PERMIT

SEWAGE DISPOSAL SYSTEM

MARYLAND STATE DEPARTMENT OF HEALTH

PROPERTY OWNER Herbert Steiner middle way in on Driver Road (Main house) STOVE HOUSE

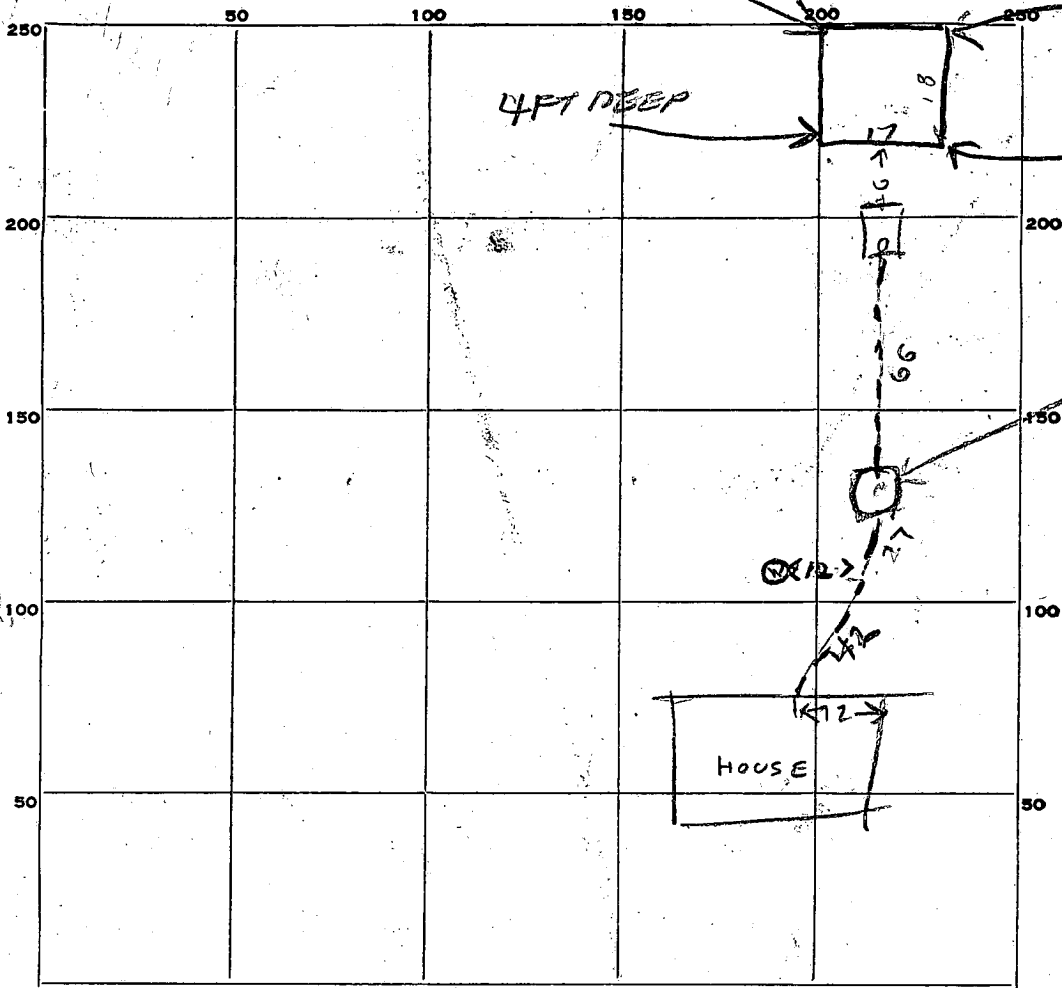
SEPTIC TANK CAPACITY 750 GALLONS to be at least 50 ft. from water well.

OTHER REPAIR - 300 sq. ft. absorbent area of dry well or tile field.

NOTE: ALL SEWER LINES WITHIN 50 FT. OF WELL MUST BE 4" CAST IRON PIPE WITH LEADED JOINTS.

Sewer line must be at least 10 ft. from water well. Dry well or tile field must be 100 ft. from water well.

REMARKS 7/17/69 - Soil in bottom of bed looks sandy
Dug Bed about 1 FT deep, Add 3 FT stone, Install Cast Iron
sewers & call for reinspection R/T
Loaded cast iron sections to septic tank.
